THE NORTHERN BEACHES HOSPITAL (STAGE 2)

SUBMISSIONS / PREFERRED INFRASTRUCTURE REPORT

PROJECT REFERENCE: SSI 6792

9 April 2015

Figure 2

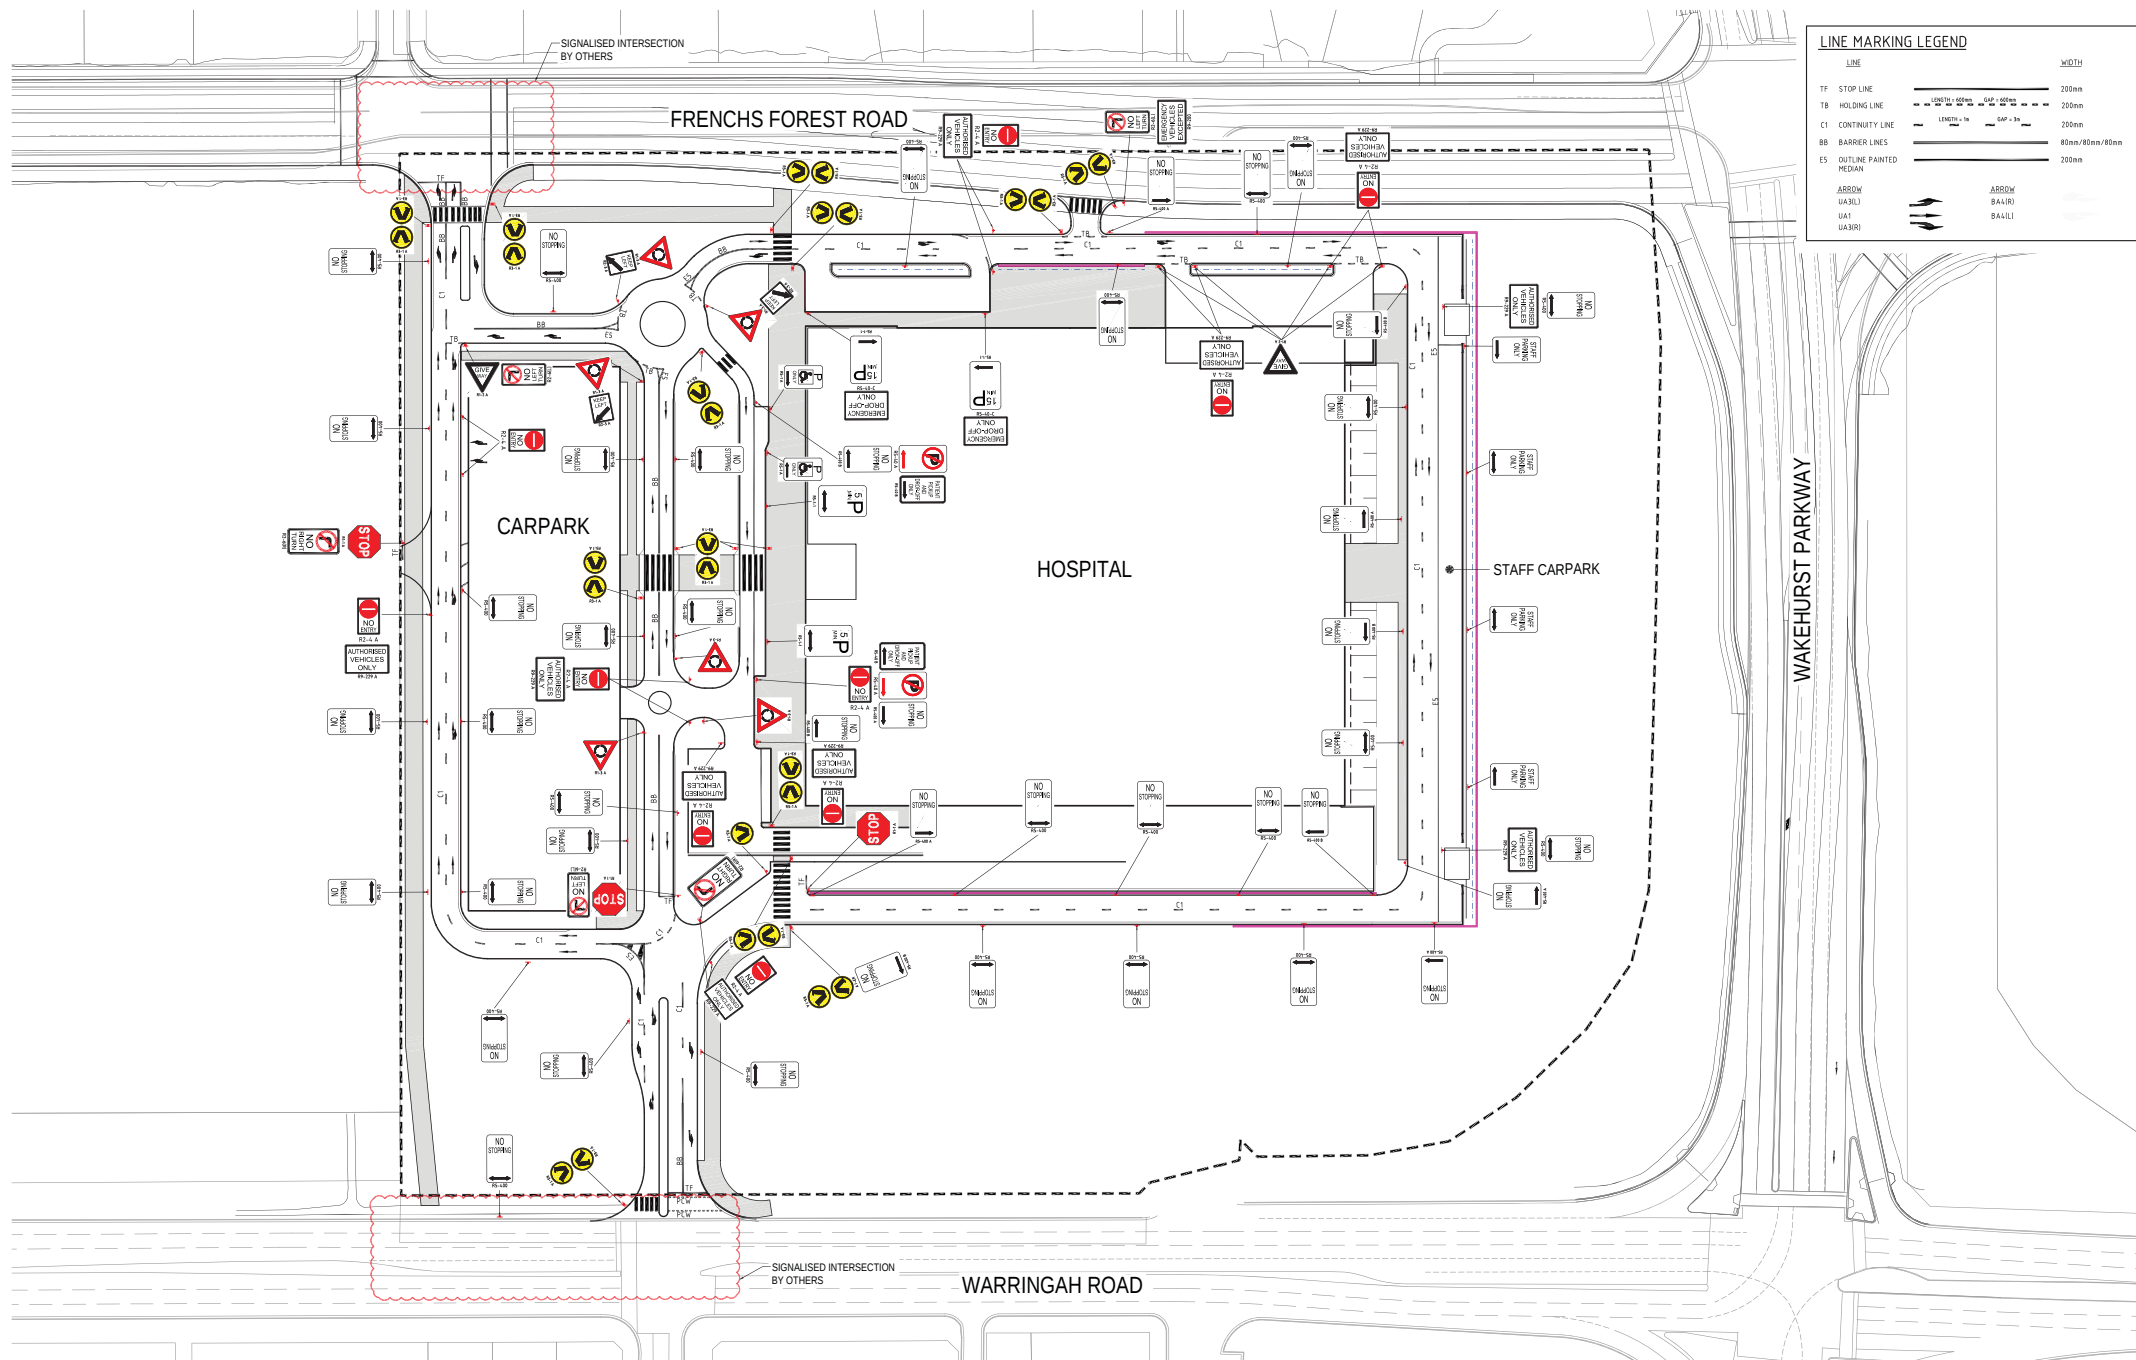
Comment	Response
5. Vehicle Circulation Patterns Provide further details of vehicle circulation patterns and any measure to control movements, including any boom gates and signage details, to demonstrate safe and clear movement patterns within the site.	The Primary Traffic Flow Diagram (refer Figure 1) shows the pattern of vehicular movement within the hospital site. Essentially all public vehicular access is restricted to the western sector, which is linked to the site access points on Warringah Road and Frenchs Forest Road West. The 'public' road network provides access to:- ▪ The emergency department in the north ▪ Hospital drop-off / pick-up to the west of the hospital complex and various access and egress options for the carpark structure. The drawing also indicates the restrictions on public vehicle access to the eastern and southern sectors of the hospital which are restricted to ambulance access to the emergency department, as well as mental health, hospital staff access to at-grade car parking in the eastern sector, together with service deliveries to the basement loading dock. The drawing highlights a further restriction on public vehicle access to the patient pick-up and transfer area located immediately to the south-west of the hospital building. The drawing also identifies the primary pedestrian path systems that will provide linkages from both Frenchs Forest Road West and Warringah Road, as well as from the main carpark, to the hospital entrance.

Comment	Response
	The supporting signage and line-marking plan (Figure 2) identifies the indicative location of signage throughout the NBH site, including stop signs, pedestrian crossing signs, round-about signs as well as no-stopping signs. The only provision for boom gates will be within the main carpark structure to control access and egress.

Figure 6

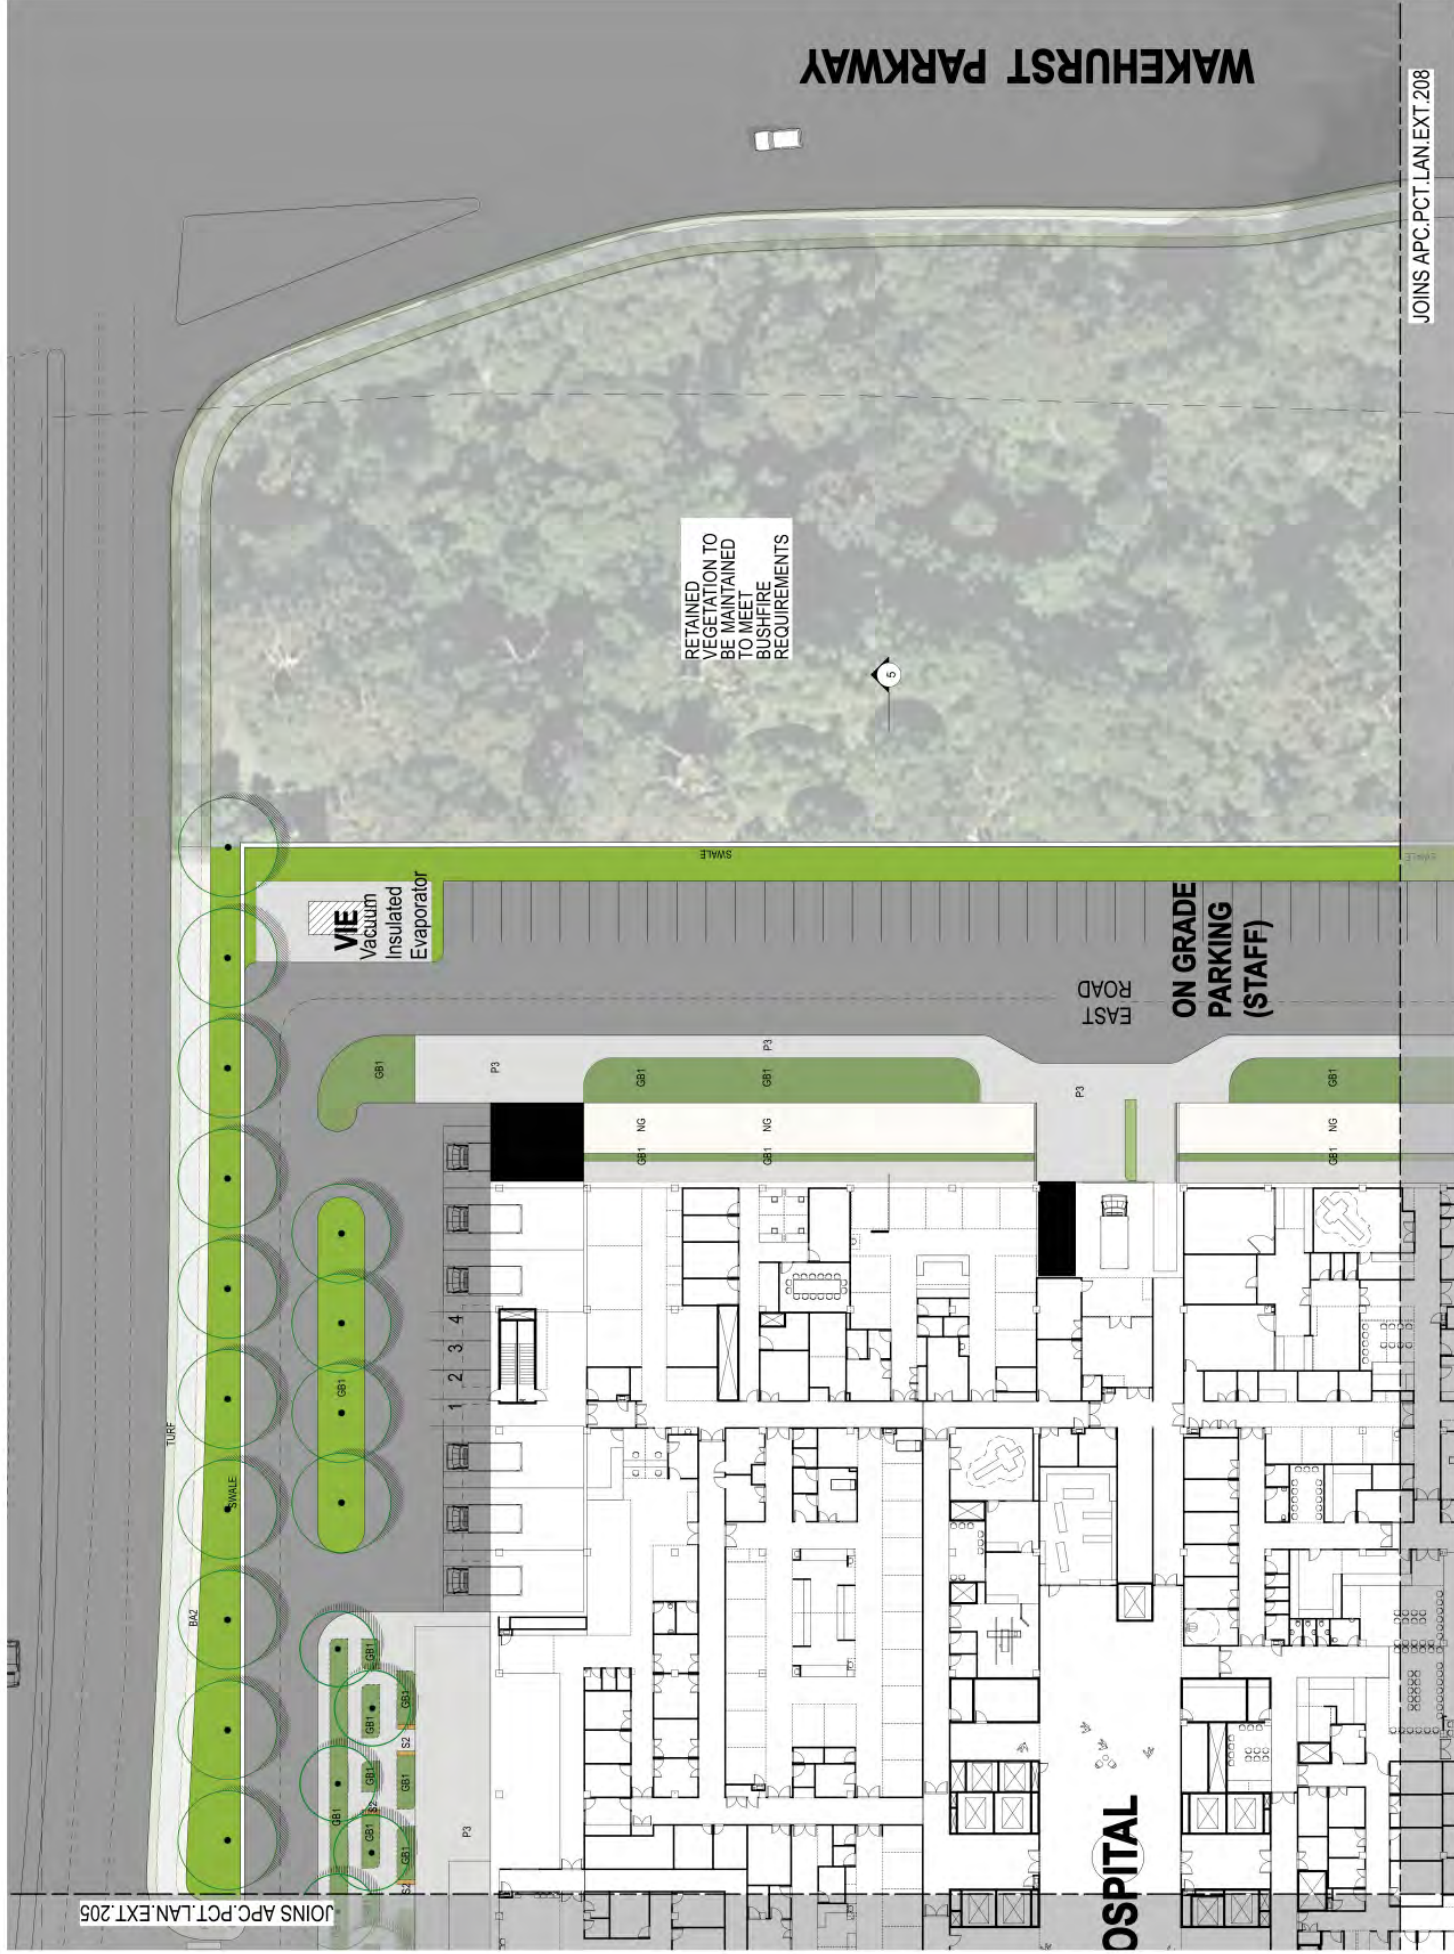
Comment	Response
Provide additional images and a northern elevation landscape plan to illustrate the treatment along the northern boundary of the site.	Section BB is through the hospital and highlights the extent of basement excavation and the ramp to the loading dock at the basement level. Section CC is immediately east of the hospital and shows the retaining wall structure to the Frenchs Forest Road West frontage identified in the Stage 1 Modification Application. The sectional drawings indicate that, with the exception of the retaining wall structures to the north-east quadrant of the building complex and the excavation associated with the hospital basement and the carpark structure, the finished ground levels are broadly consistent with the existing site levels. Figure 5 – Landscape Sections & Figure 6 – Landscape Plan (North-East Quadrant) provide updated information relating to the on-grade staff parking, proposed landscape treatment and the retaining wall structure immediately east of the hospital. Landscape Section 5 now correctly shows the relative levels of the staff carpark, the hospital basement and the existing ground levels in the former Blinking Light Reserve. Figure 7 is a detailed drawing illustrating the northern elevational landscape treatment to Frenchs Forest Road West. The drawing is based on the Stage 2 landscape plans and the submitted planting schedules.

FIGURE 8: HELIPAD LOCATION
(4.02.15)

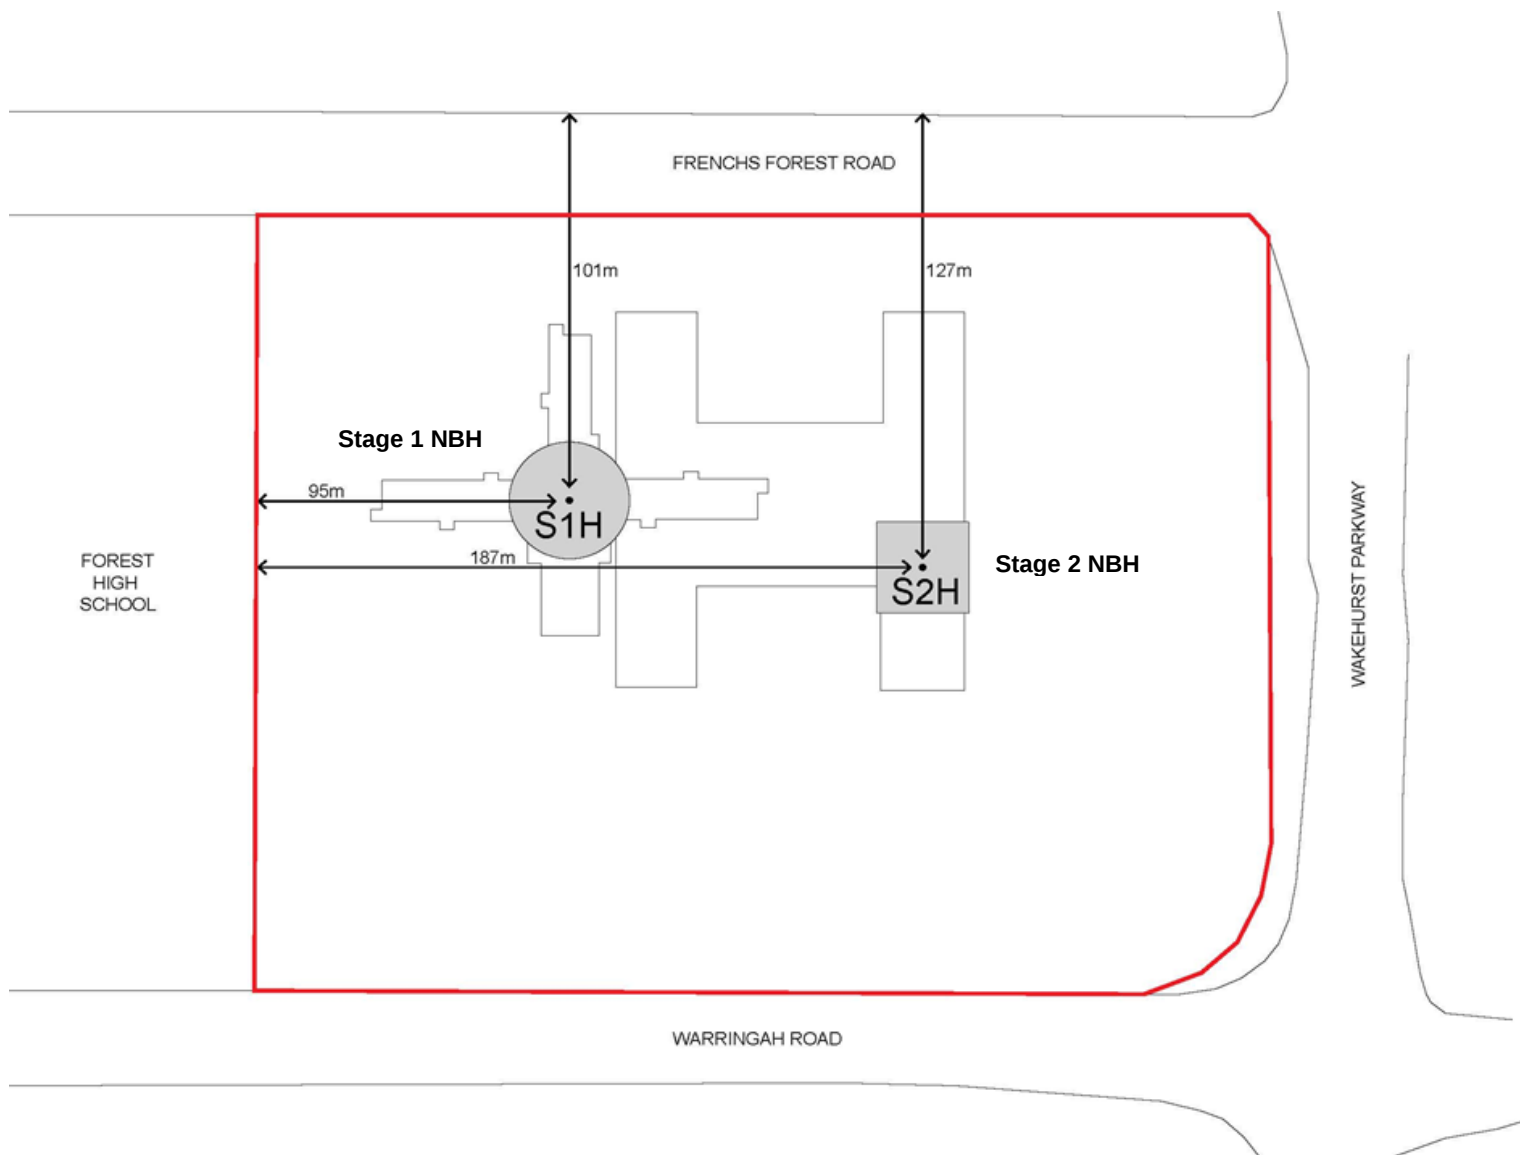
Comment	Response
13. Helipad Provide details of the approach and departure surfaces for the helipad and demonstrate that the design of the building and location of the helipad ensures that approach and departure surfaces are orientated to minimise acoustic impacts on adjoining sensitive receivers.	Section 6 of the Revised Stage 2 Noise and Vibration Report provides assessment and discussion regarding the siting and design of the Helipad. As acknowledged by the EPA in their responses, “the helipad is to be located towards the south eastern corner of the roof of the hospital building with a view to minimising noise impacts on surrounding residents”. The preferred flight arrival and departure path is detailed as east-west direction at 7.5 degrees. It is noted that the approved Concept Plan provided for a helipad located some 100m south of residences in Frenchs Forest Road West and approximately 95m east of the Forest High School boundary. The proposed Stage 2 helipad is further removed from sensitive receivers being located approximately 130m south of the Frenchs Forest Road West residences and 190m east of the school boundary. Figure 8 identifies the proposed location of the Stage 2 helipad as well as the earlier Stage 1 Concept Plan location. The Stage 2 design provides for plant and lift elements north of the helipad as well as the carpark structure to the west. These elements, together with the substantial increase in separation, will help ameliorate acoustic impacts.

FIGURE 9: NBH SETBACK FROM FRENCHS FOREST ROAD
(4.02.15)

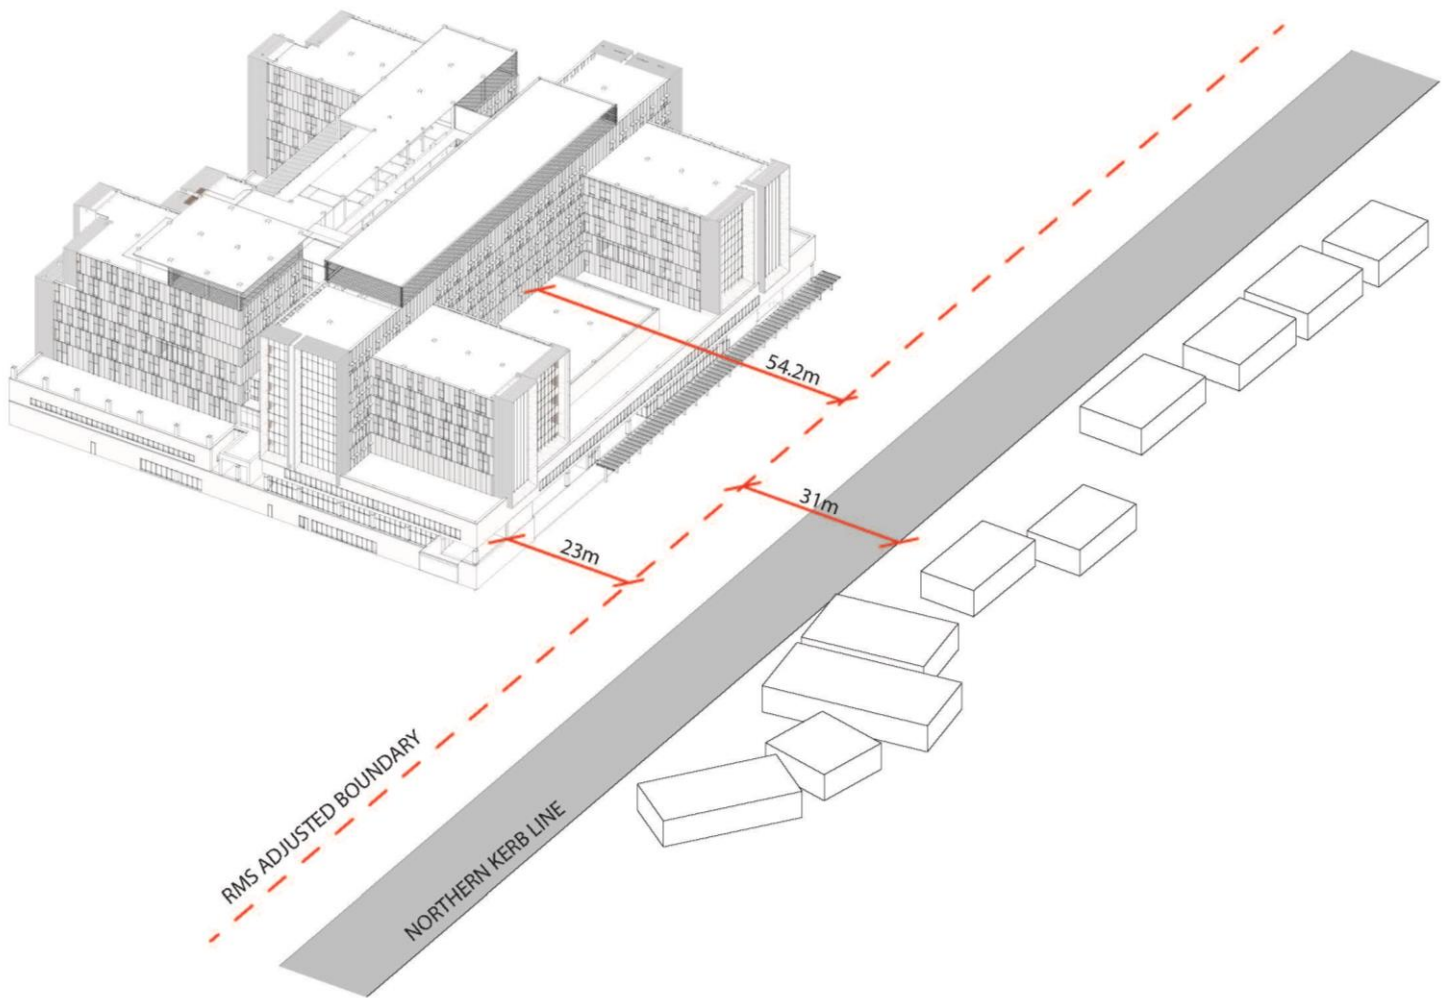
Comment	Response
9. Landscape The following development assessment related comments are provided for consideration: (Frenchs Forest Road West) The depth of landscaping within the front setback to Frenchs Forest Road West needs to be confirmed as adequate (in terms of the height of native trees at maturity) for a nine storey building fronting a secondary road, which is otherwise characterised as a bushland lined streetscape. Additional depth and density of landscaping is considered necessary.	
	A layered landscaping approach has been adopted for Frenchs Forest Road West. The design, which takes into account the general bushland setting of the surrounds, provides for native landscape planting along the northern ground plane, supplemented by ground cover planting to the Frenchs Forest Road West frontage. A layer of landscape at the hospital 'ground' level supported by the retaining walls provides additional tree grove shielding which is further extended in the planting associated with the landscape spine and the extension of the landscape spine at the western end of the Frenchs Forest Road West frontage. Although the approved concept plan requires that the building be set back a minimum of 6m from the Frenchs Forest Road West boundary, the Stage 2 proposal provides for a setback of 23m from the expanded (31m) Frenchs Forest Road West to ensure that a layered landscape approach can be achieved.
